C2150x MAIN FIRMWARE RELEASE NOTES

WM-Ai & WM-Ai-P Auto Wrappers and IP-Ai Pre-Pack Scale

Insertion Plate. Top: new coating (darker), bottom: original coating (lighter)

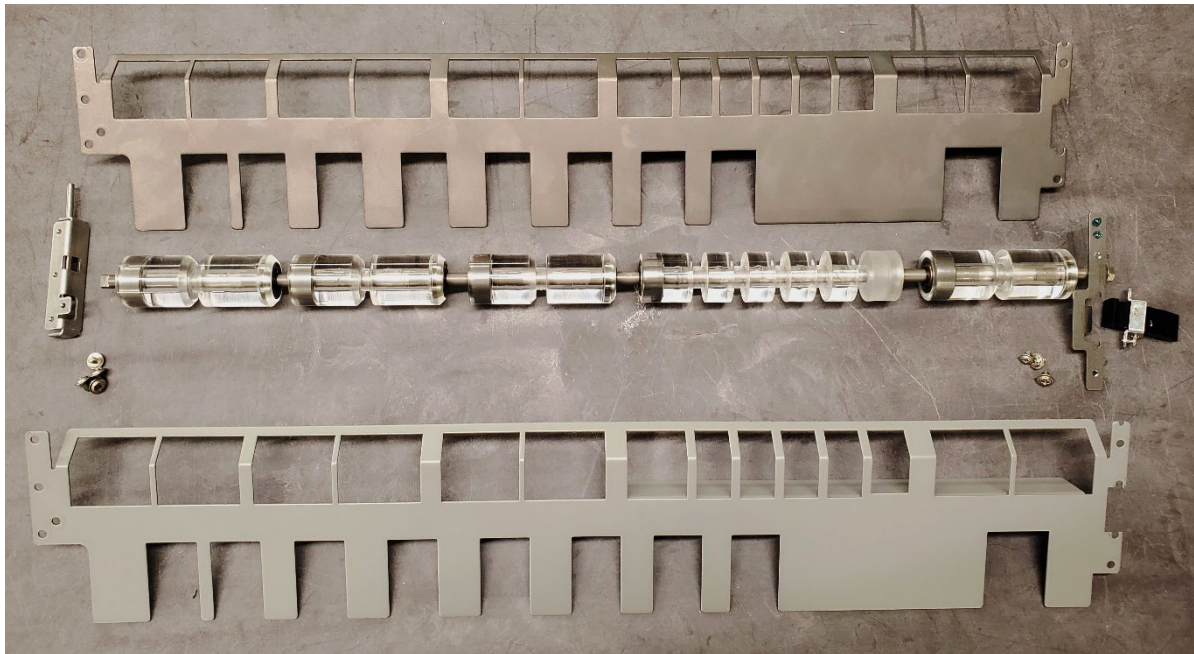
1. Added support for an updated Insertion Plate that is coated with a different material. An incorrect setting will affect film feeding. The updated insertion plate is factory installed on the WM-Ai-P model only from s/n 100504904, mfg. date October 2020. Adjust menu > Wrapping Machine > Film tab > Insertion Plate.
 - New – Set when the updated Insertion Plate is installed on an older wrapper
 - Old – Set when a wrapper has the original Insertion Plate (default)
 - SP – Set at the factory when new wrappers are built with the updated Insertion Plate
2. Fixed a bug where the last character of the date did not print when the Character Pitch spacing was set as zero (0).

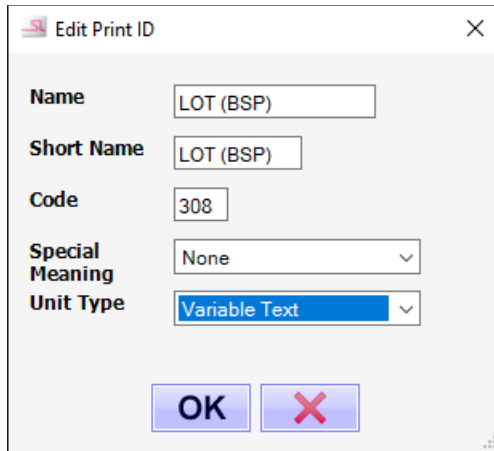
- g. Label format Print ID 134: BSP LOT (308 in SLP-5) is used to print the Lot Number. The field is changed from Numeric to Variable Text for this version of Lot Number.

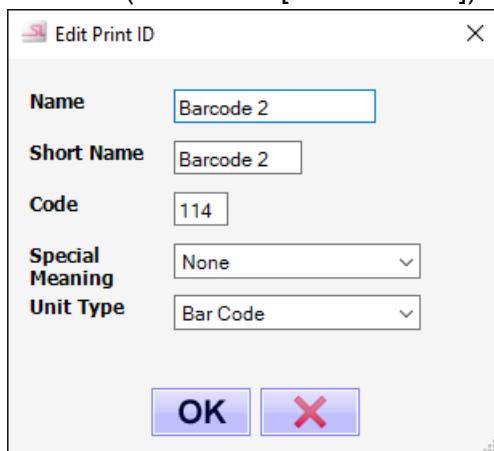
3. Added a feature to switch between UPC and GS1 barcode formats based on the total price. When the total price is 4-digits or less the standard UPC barcode format prints. For a 5-digit or 6-digit total price the GS1 barcode prints.
 - a. Added Print ID BARCODE2 72 (114 in SLP-5)
 - b. If the price exceeds 4-digits, Barcode2 will not print if it is not included in the label format.
 - c. When the total price is 7-digit or more neither barcode is printed.
 - d. BARCODE2 prints a custom barcode but operates separately from the standard Custom Barcode (Print ID 71 [113 in SLP-5])
